ADDENDUM #1

to the REQUEST FOR PROPOSALS FOR SURVEILLANCECAMERA SYSTEM

RFP Bid No.20/21-0002

ROSEMEAD SCHOOL DISTRICT

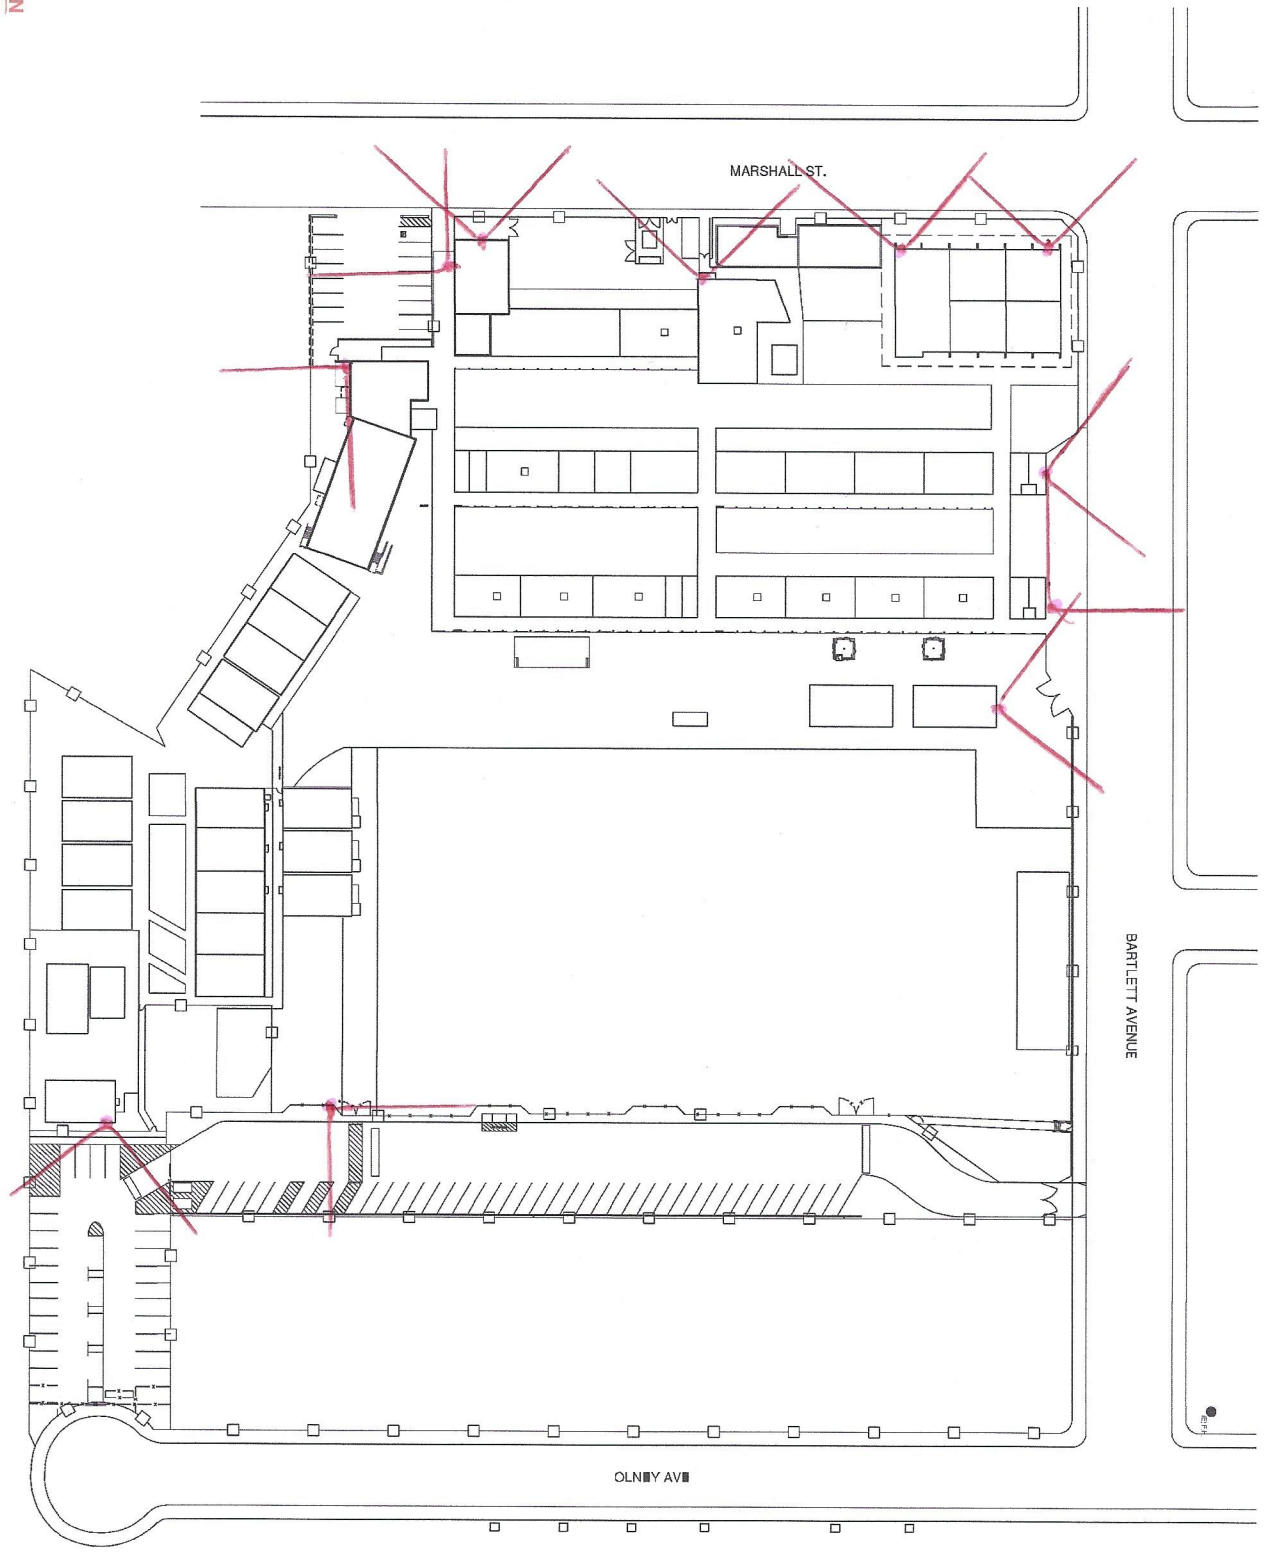
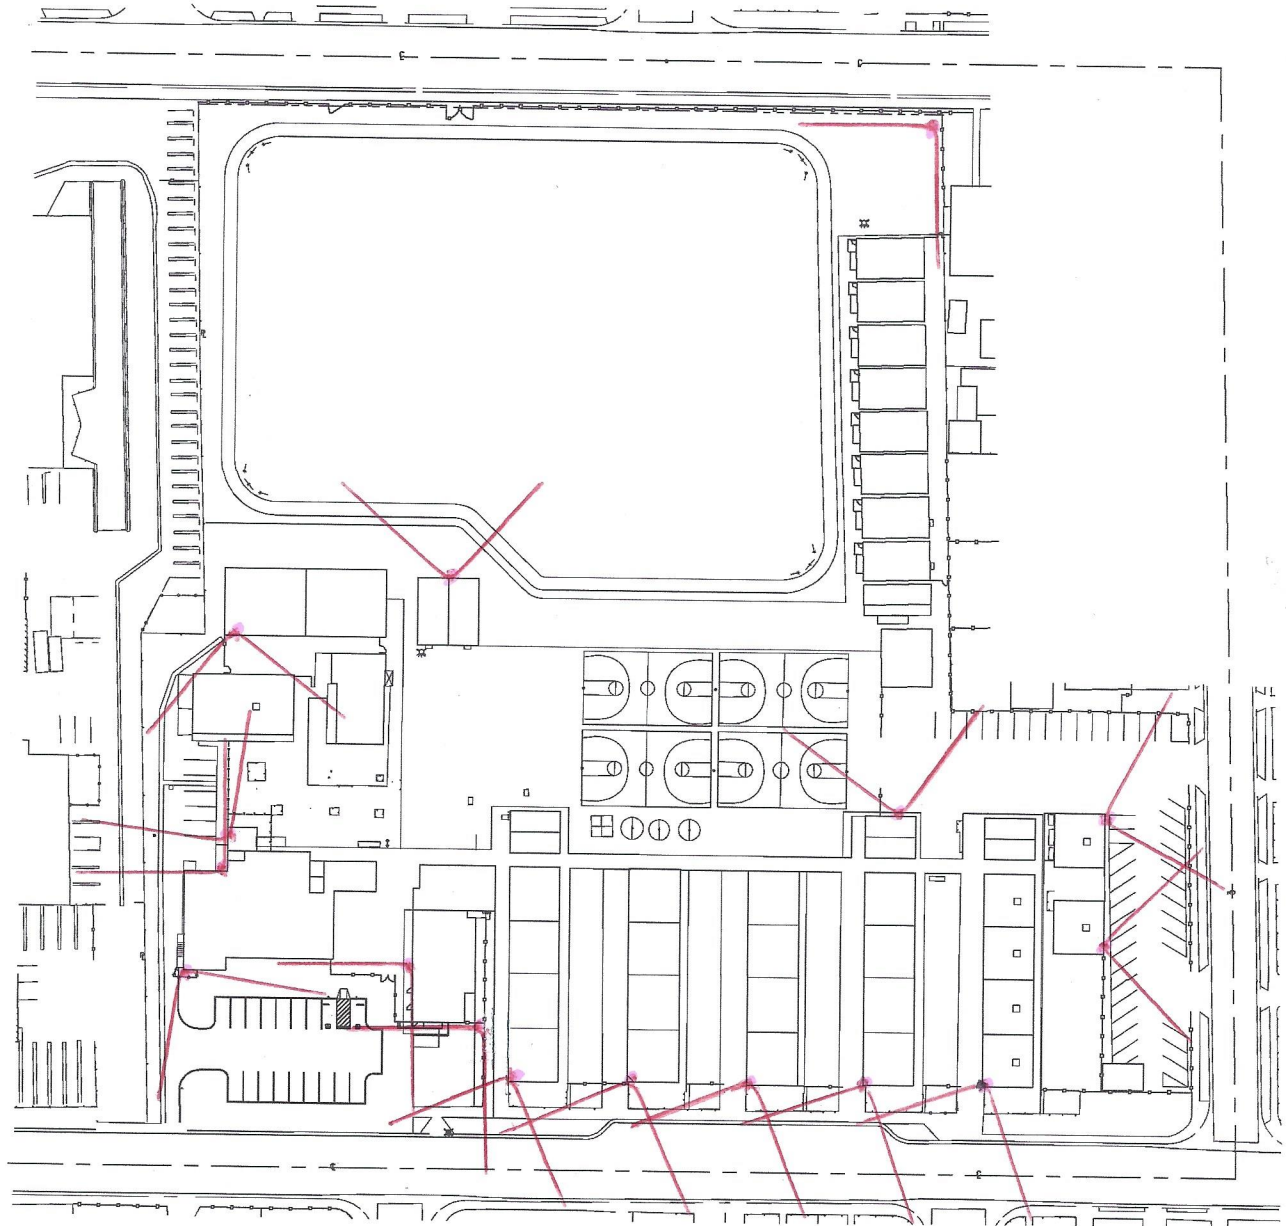
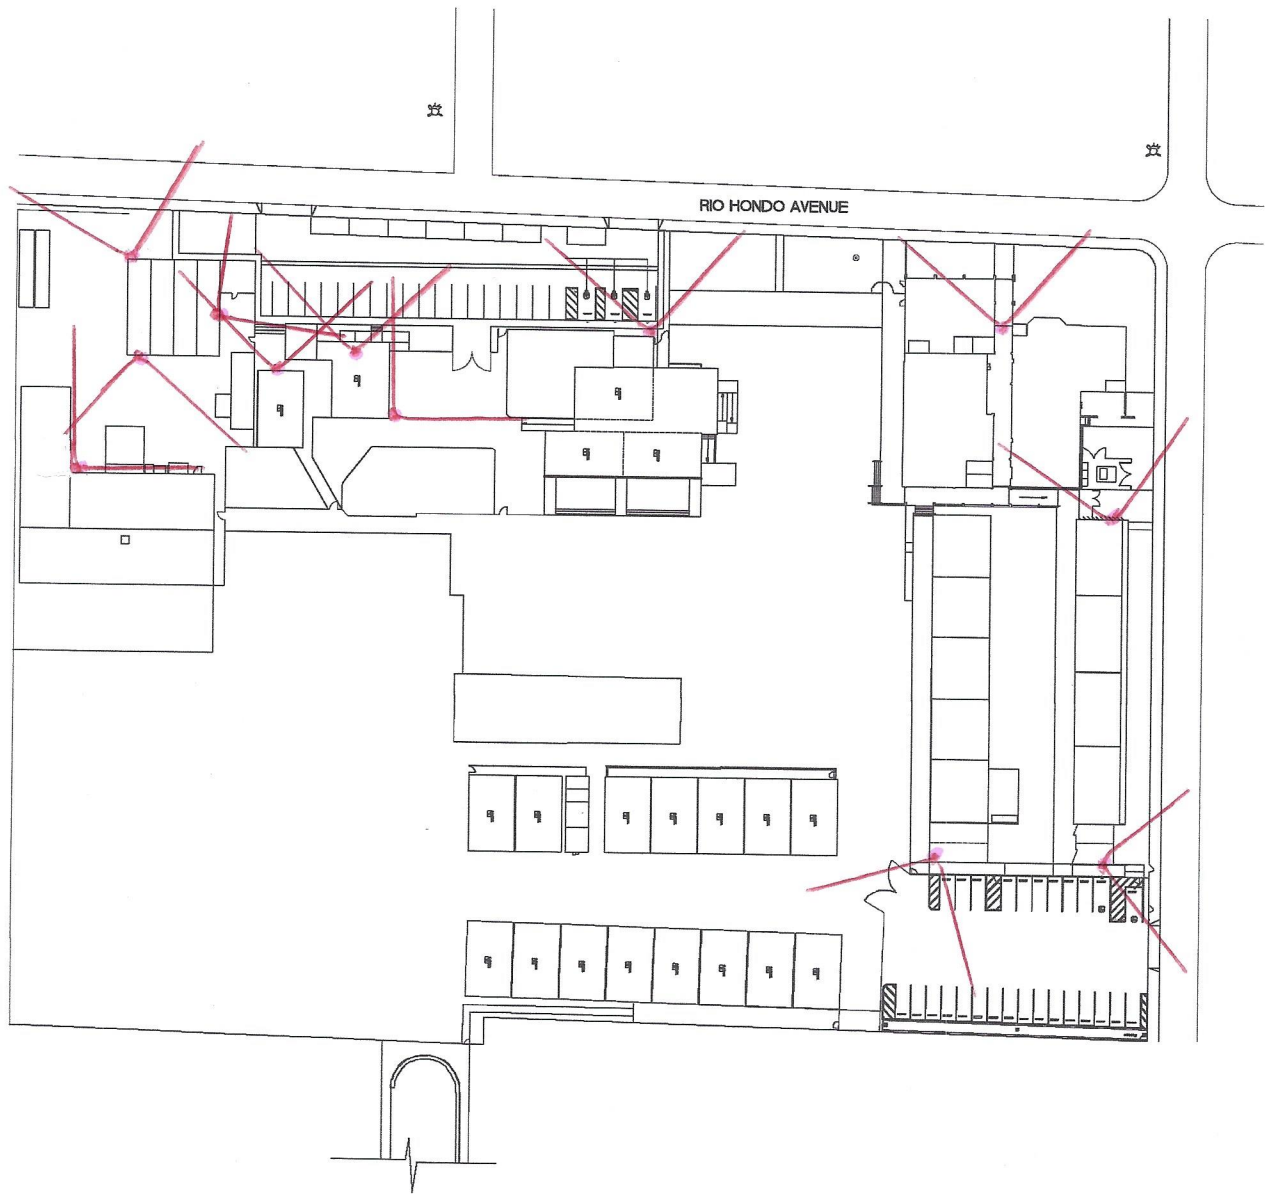
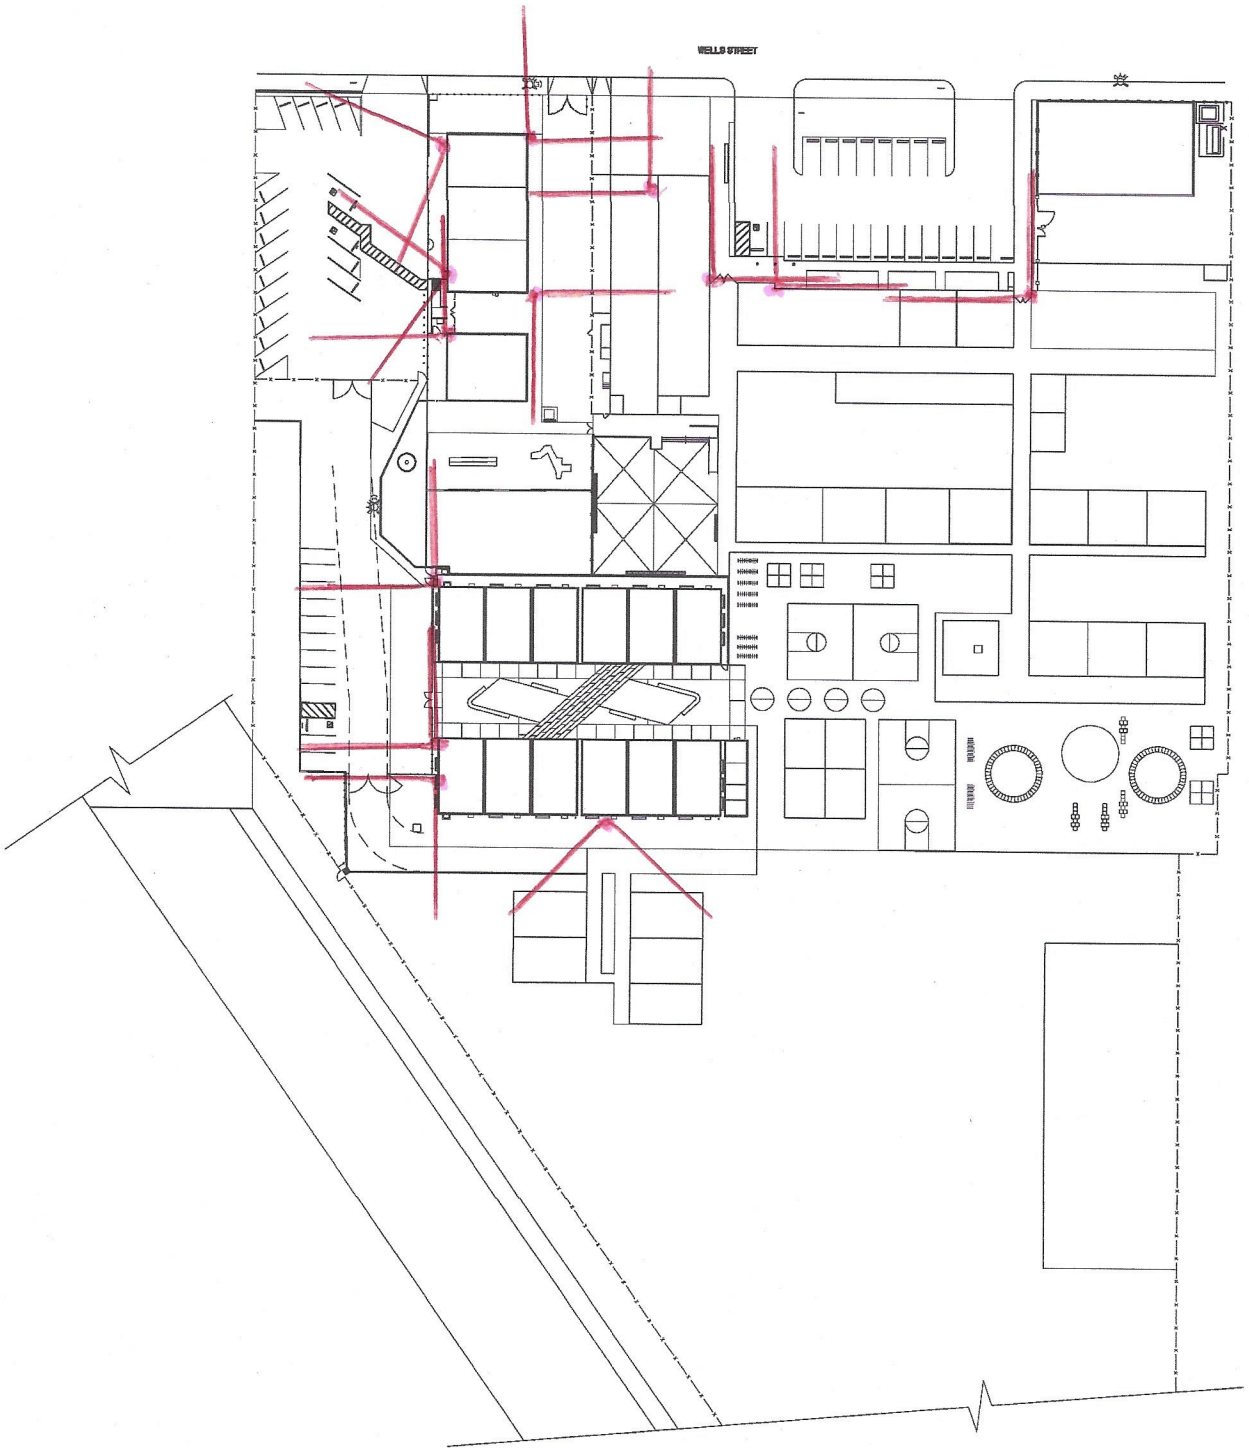
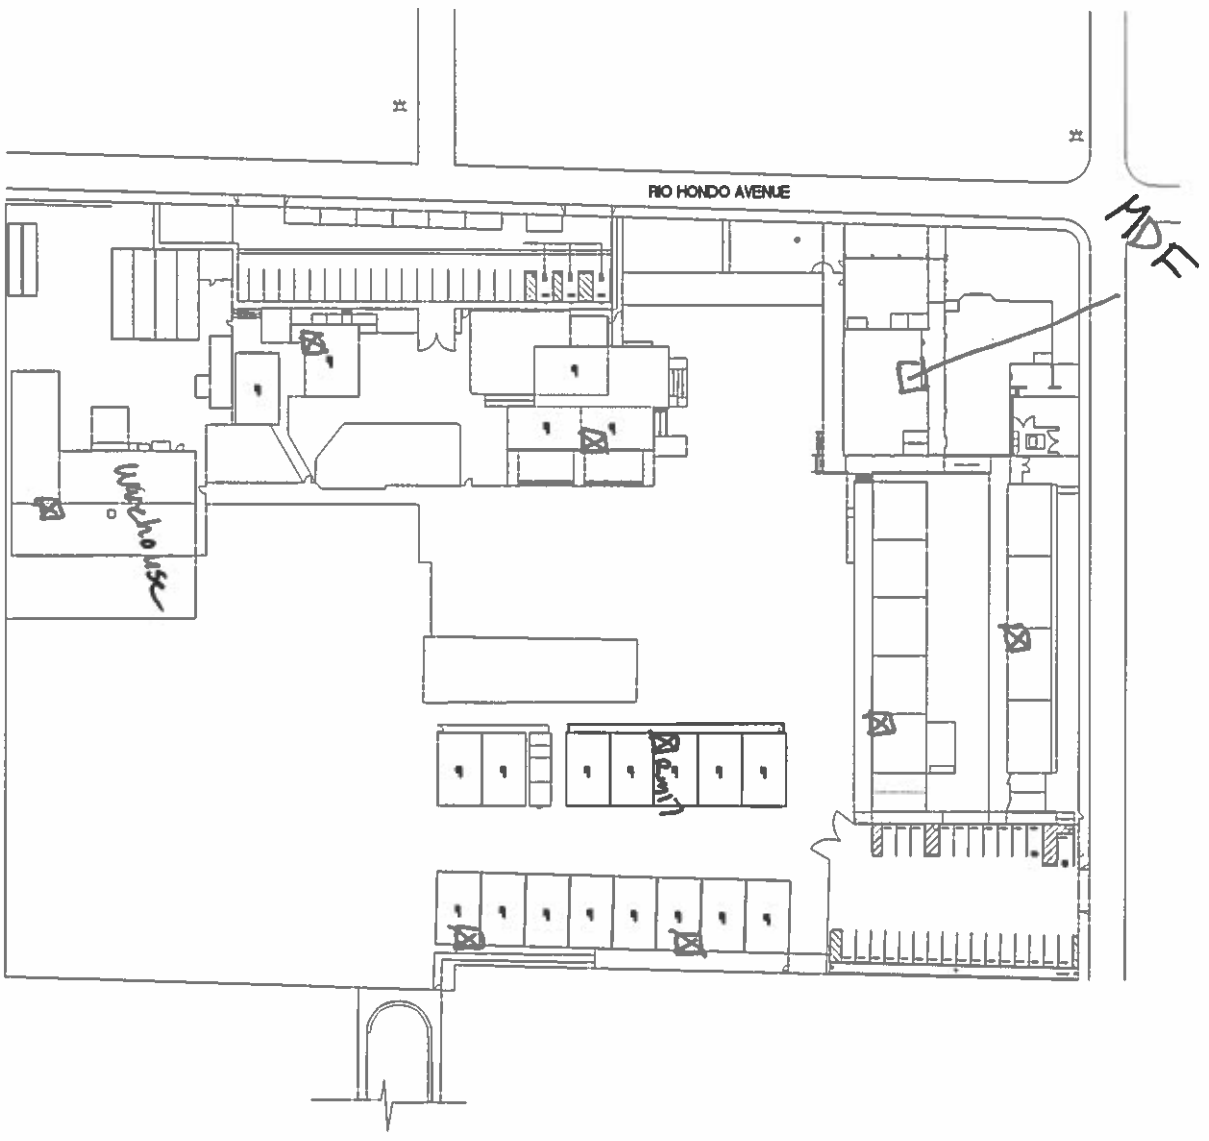
- E. The camera location site plans attached to the original RFP are replaced by the camera location site plans attached to this Addendum. All cameras (with two exceptions) are now to be attached to buildings. Exception #1 is at the northwest corner of Muscatel which will require a new pole for mounting and trenching for new power and signal. Exception #2 is at the east side of Janson where the camera will be mounted on an existing light pole using existing power.
- F. Also attached to this Addendum are site plans showing the locations of the MDF and IDFs.
- G. Clarification Questions have been received and the responses to these questions are provided below. Questions have been edited or reworded as needed for clarity, and when/if applicable, multiple questions on the same subject have been combined. Questions are numbered. **Responses follow each question in bold.**
